BEFORE THE BOARD OF ZONING ADJUSTMENT
OF THE DISTRICT OF COLUMBIA

Application for Variance Relief
For Variance Relief
#19614

STATEMENT OF ADJACENT PROPERTY OWNERS
IN OPPOSITION TO REQUESTED VARIANCE

Property owner Barret Evans, with plans prepared by Cunningham Quill Architects, requests the Board's review of a concept to construct two three-story two-unit rowhouses, along with a subdivision to permit the construction and site work.

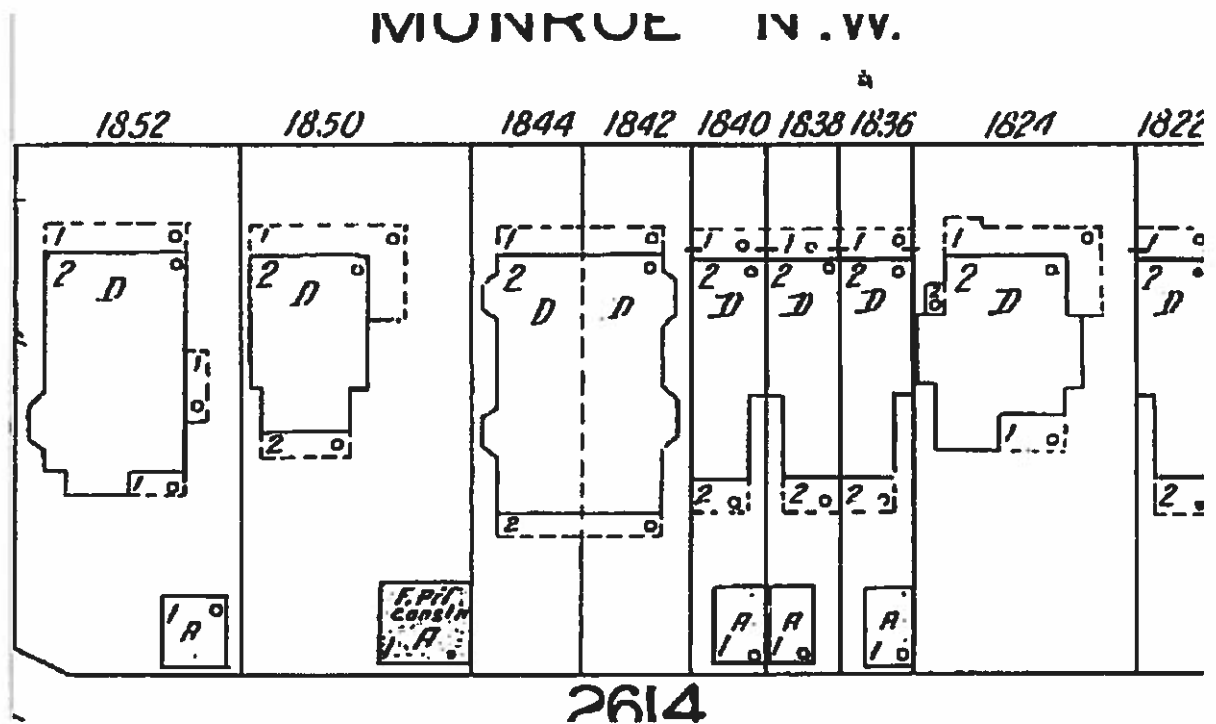
The present proposal was in some sense inspired by the design and even historic use of the former building on the lots, with the same front-yard setback and approximate depth. But it is both taller and wider and expressed not as a double house, but as a pair of flat-roofed three-story rowhouses stretching lot line to lot line.

At a full three stories, the buildings are imposing relative to their neighbors. A grade slightly depressed relative to its neighbors' and a lower first-floor height mitigates the height somewhat, but the standardization of the ceiling heights at over nine feet pushes the total higher. A lack of hierarchy and differentiation contribute to the impression of a big building. Other buildings are lower or seem so by decreasing the ceiling heights with each story and expressing a third level as an attic story, with the cornice or eave height dropped below.

It is not the height per se, or at least the height alone, that is the issue—there are, after all, three-story rowhouses across the street and others elsewhere in the district—but it is the height taken together with the width and depth of each building that make the new construction stand out relative to its immediate neighbors. At 25 feet, these are near the maximum width of D.C. rowhouses. The historic rowhouses on Monroe Street are generally around seventeen feet wide, although there are some at 20 and 23 feet, but with more pronounced bay projections. The remaining twenty-five-foot-wide lots on Park Road hold semidetached homes. The proposed houses are comparable only to the broadest rowhouses within the historic district, down on Lamont and Kilbourne near 17th Street.

So, the proposed widths are not unheard of in the historic district, but in this spot, one cannot help but compare the dimensions and proportions of each of the proposed buildings with those of the not especially modest, detached house at 1850 Monroe. In the pattern of this street, and of most streets, it is the detached houses are the larger, or at least the wider, homes. Going somewhat higher than 1850 is not itself a problem, but that house does seem somewhat overwhelmed by the proximity of such a large block. It would be well to revise the massing of the project to sculpt and modulate it, to give it more internal hierarchy and a better relationship to the neighbors. In short, approaching this project more like the double house that once stood there would be more compatible, although it would have the problem of conforming with side-yard zoning requirements.

If one were to stick with the present approach, however, more can be done to distinguish the two houses—without using the forced device of using different colors of brick, which seems inappropriate for mirror-twin houses sharing a cornice. Smaller devices, such as reveals in the brick at the corners of each house and further separating the porch roofs might distinguish them further. The two-foot bay projections should be deeper, and the double-ganged windows over the front entrances should be narrowed to a single large window each, both to avoid a relentless fenestration pattern across the façade and to give more solidity to the main mass as distinct from the bays.

HPO recommends that the Board approve the subdivision in concept and support the concept of two "flats" buildings, but that it request revisions to address the issues raised above.

ATTACHMENT E-1 (Excerpt from permit drawings – Monroe Street frontage)

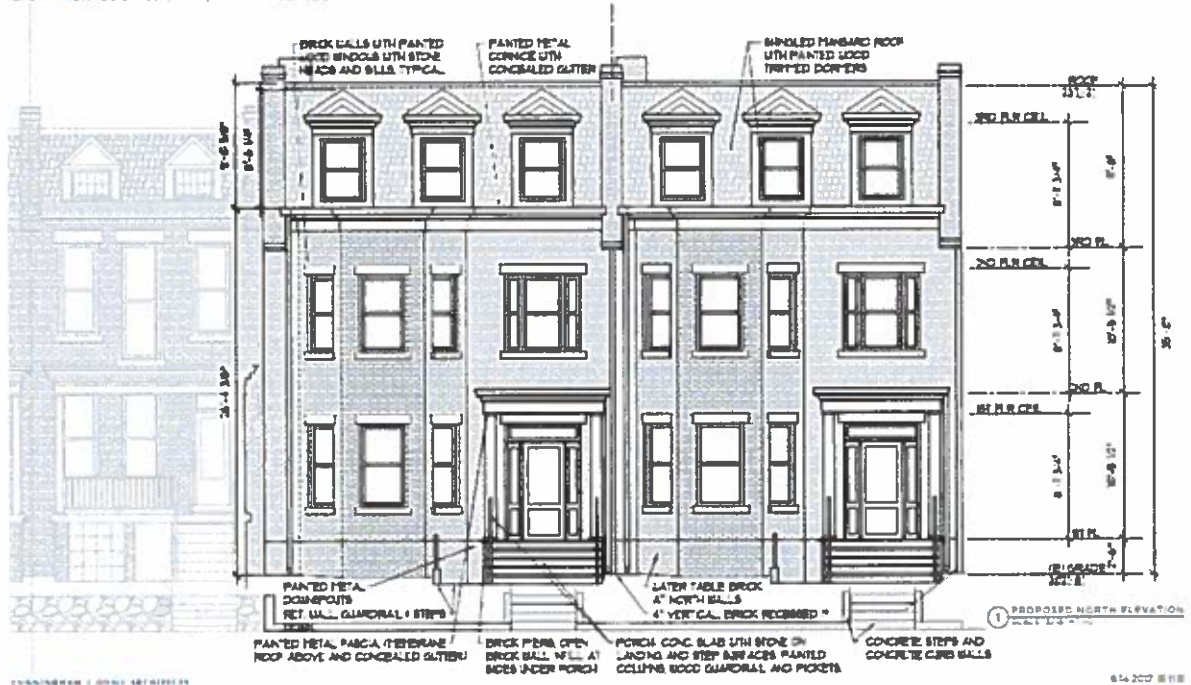
The proposed buildings also tower over the neighboring rowhouses to the east, because the plans provide for three full, above-ground stories -- rather than the 2½ stories typical for the block (as shown most clearly on the east elevation drawing). The buildings also extend well past the neighboring rowhouses into the backyard, and, as the southern elevation of the permit drawings demonstrates, the height, width and shape of the proposed buildings overwhelm their neighbors visually. *See* Attachment E-1, E-2 (excerpts from Applicant's permit drawings).

(Tree assessment and protection plan for Ash Tree at 1850 Monroe Street NW)

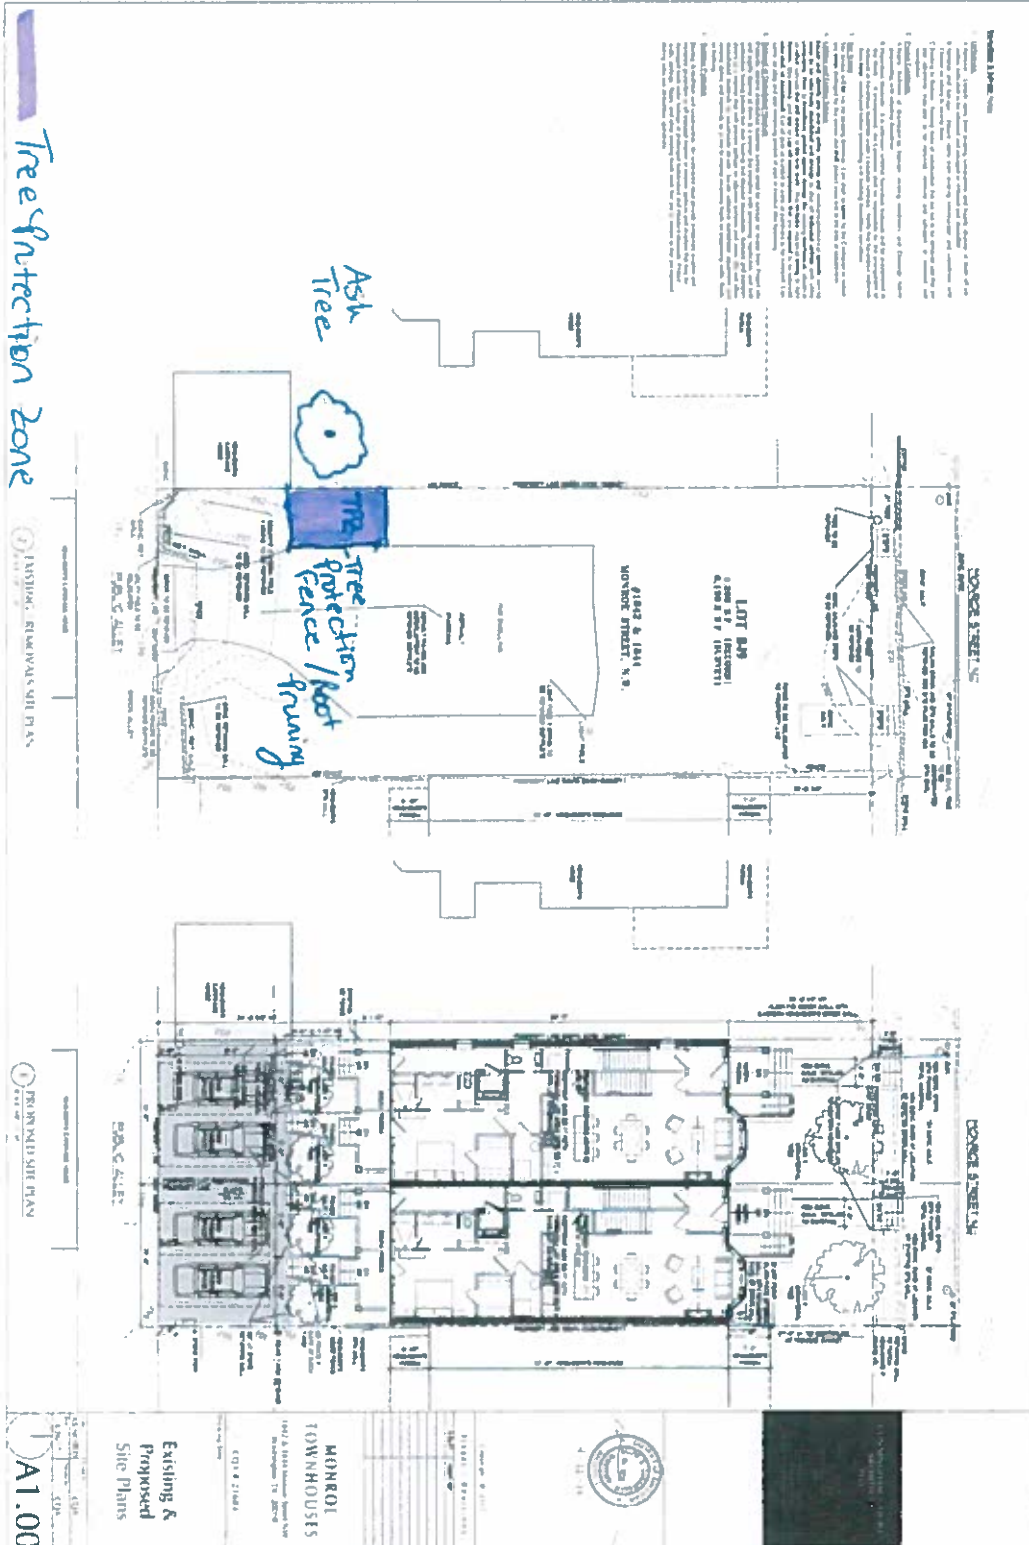
The minimum Tree Protection Zone (TPZ) radius to maintain structural integrity is double the trunk diameter. Therefore, at an absolute minimum, there may be no construction closer than 5 feet to the tree. In order to properly protect it, root pruning and a tree protection fence must be installed along a Limit of Disturbance (LOD) between the construction and the TPZ therefore; I recommend an absolute minimum of 6 feet for the TPZ.

The trees roots extend well beyond 6 feet into the vacant lot up to the asphalt and then underneath. The asphalt should be saw cut and removed by hand within the Critical Root Zone (CRZ) and be replaced by 2" of topsoil and 2" of mulch. The ideal placement of the tree protection fence and root pruning is along the line of

Attached is the site plan for 1844 Monroe Street and the Tree Protection Zone (TPZ) is indicated.
